ARCHITECTURAL  
REVIEW COMMITTEE

## TOWN OF BROOKFIELD ARCHITECTURAL REVIEW COMMITTEE STAFF REPORT

RE: ARC Staff Report – May Agenda Items

Strand Associates, Inc.® (Strand) has finished its initial review of the construction drawings and Storm Water & Erosion Control Calculations for the Quest Interiors Development that were received from the Town on April 25, 2023, for conformance with the Town specifications and general engineering practices. Before construction may begin, the contractor shall submit all required permits for the development to the state, Wisconsin Department of Natural Resources (WDNR), Town, and any other relevant agencies. New drawings, stormwater management plan and calculations, and a letter describing the revisions should be returned to Strand after the following concerns have been addressed.

CIVIL UTILITY PLAN

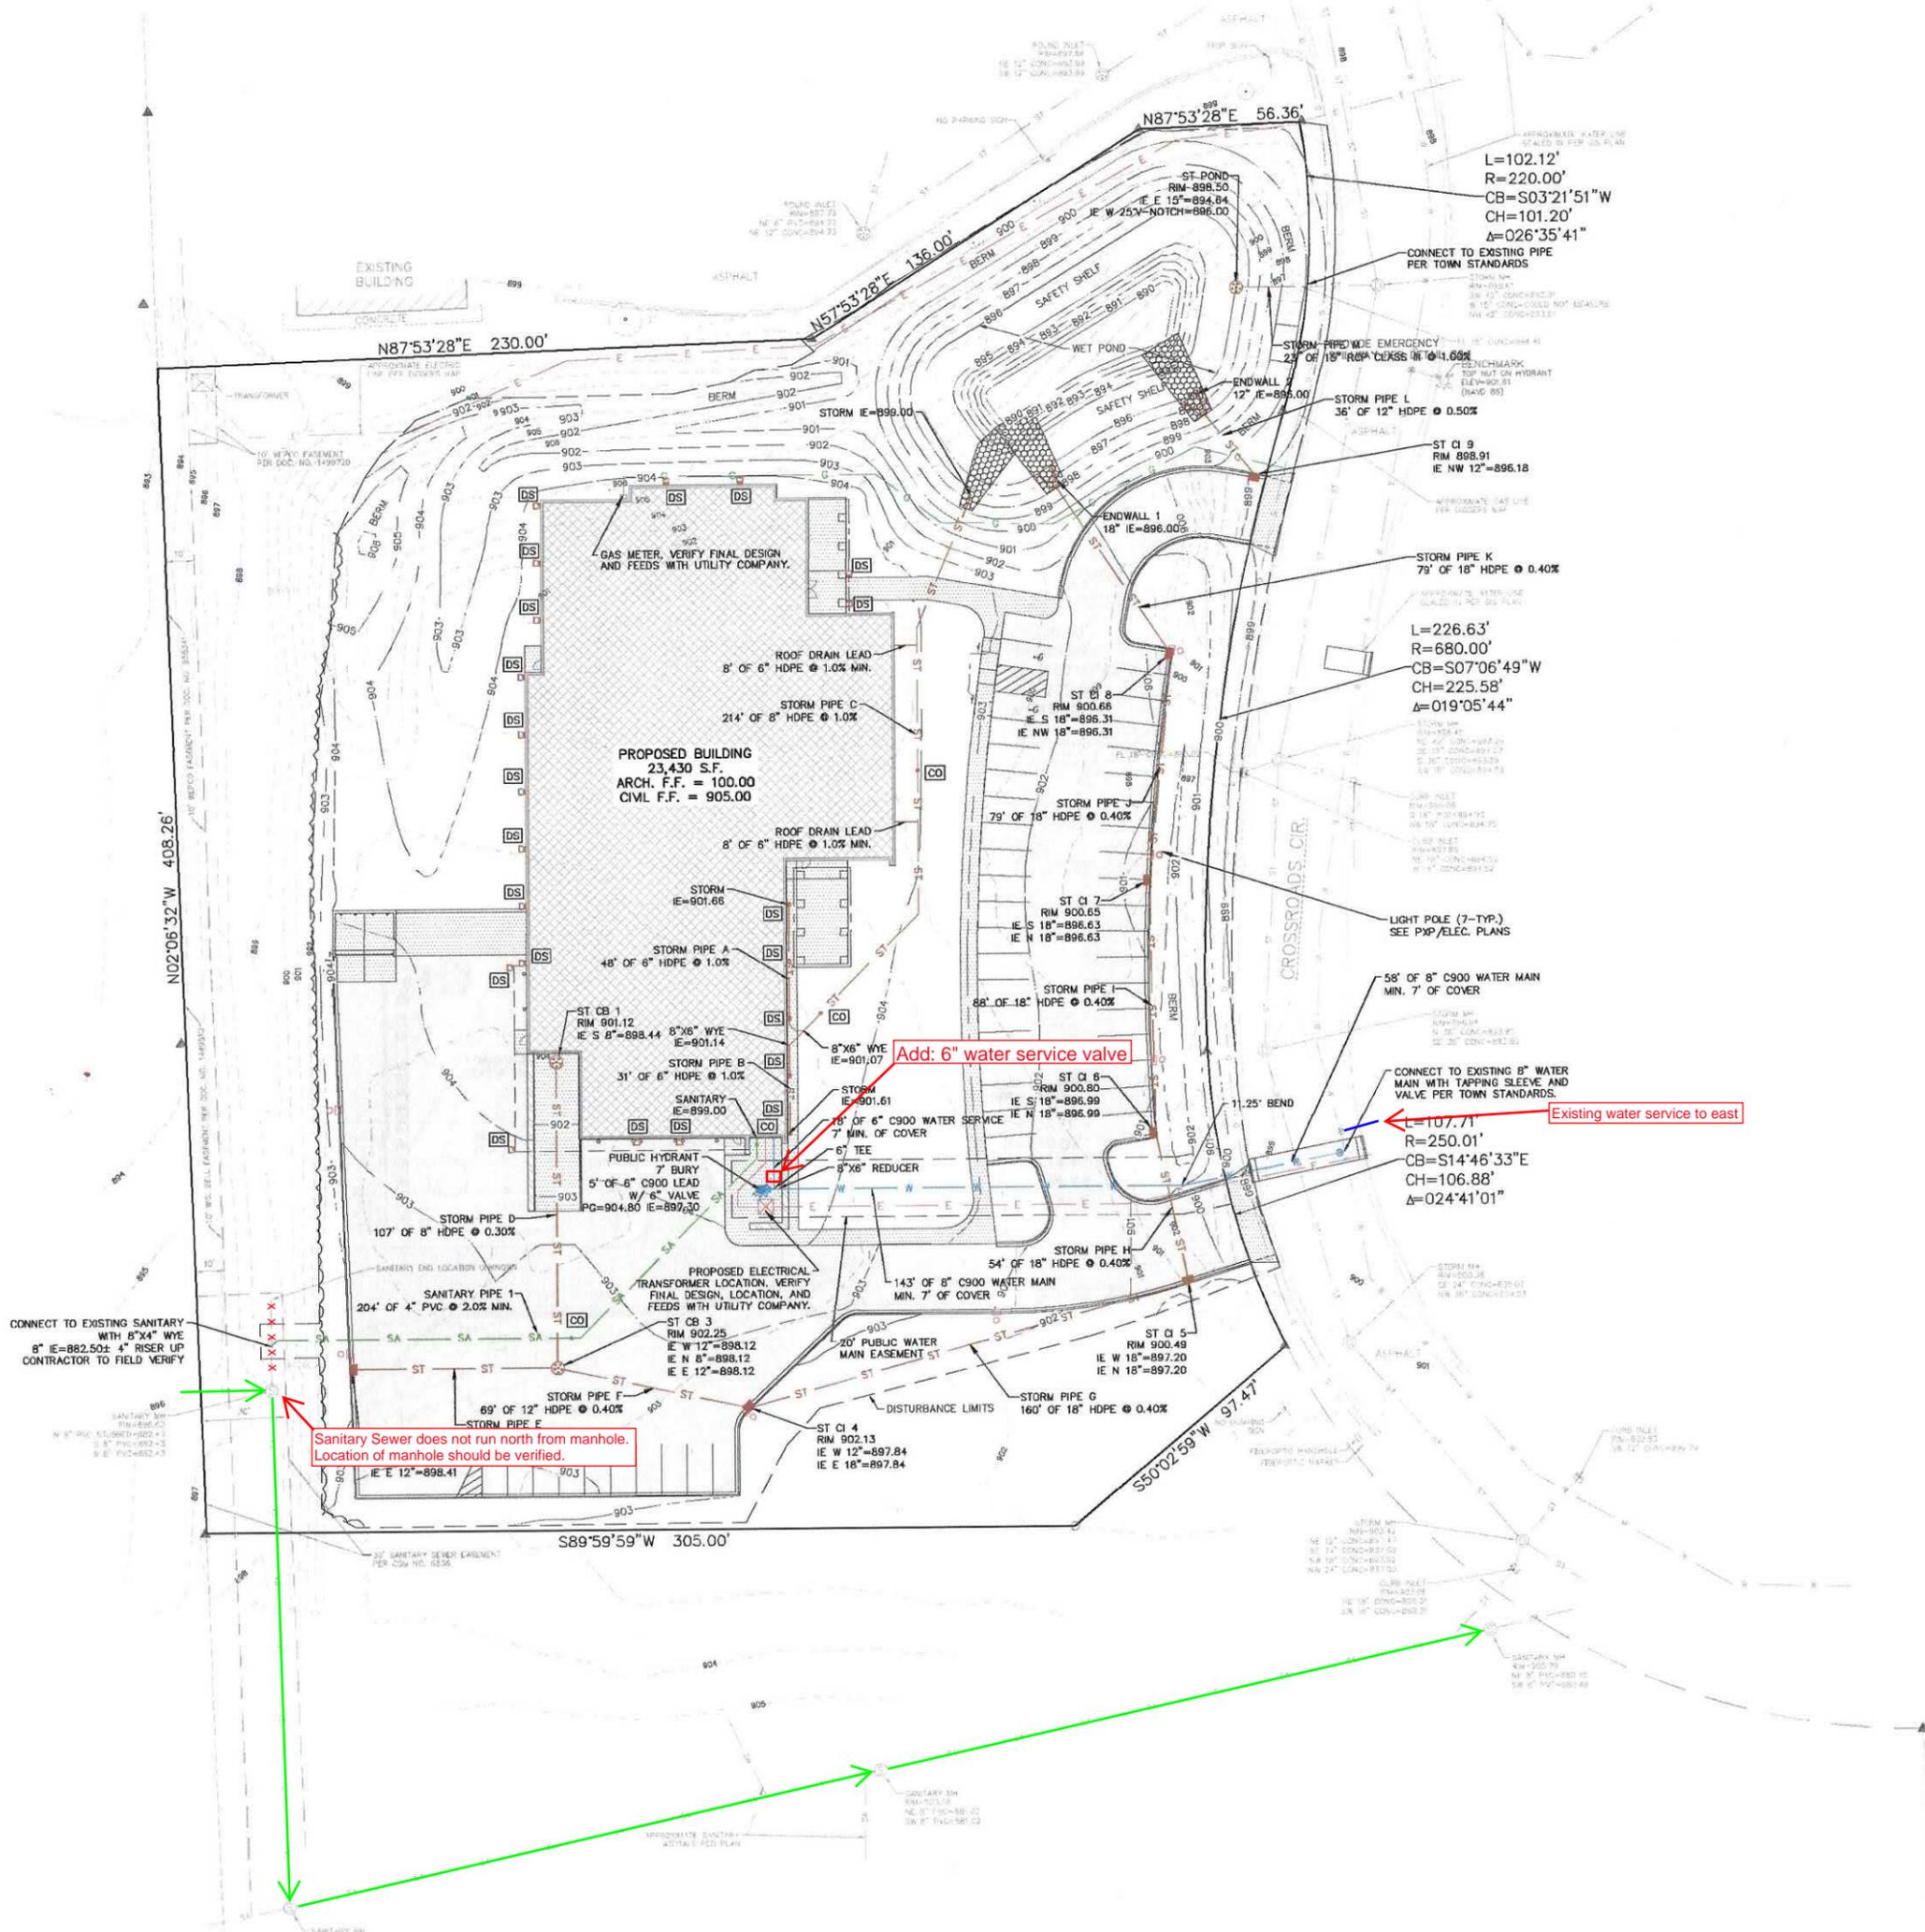
1. The callout for the rim elevation of CB-1 (901.12) does not match the callout for the rim elevation shown in the Bay Loading Dock Detail (900.90).
2. Evaluate that proper separation between water, storm, and sanitary sewer mains are meeting the requirements of Section NR 811.74 of the Wisconsin Administrative Code (WAC).

3. The storm sewer structure and casting types should be called out on the plan.
4. Review that all water main design meets the requirements of Section NR 811.70 of WAC and Section 12 of the Town Sanitary District No. 4 technical specifications (see Sections 12.1–Water Main Material, 12.2–Valve Type, 12.3–Pipe Cover and length requirements, 12.5–Thrust Restraint, and 12.18–Fire Hydrant Type). Supporting documentation should be provided.

7. The existing sanitary sewer is not shown correctly on the west side of the property where the proposed sanitary service connection to the main is taking place. The sewer main is entering the manhole from the west and then heads south. There is no sewer line running north of this manhole (see enclosed markup). This will require a modification of the proposed sewer service connection to the main.
8. A 6-inch water valve should be added to the proposed water service (see enclosed markup).
9. The proposed water main tapping location is near an existing water service connection. A note should be added stating the required distance from the existing connection.
10. The scale bar appears to be incorrect.

Sanitary Sewer does not run north from manhole. Location of manhole should be verified.

Add: 6" water service valve
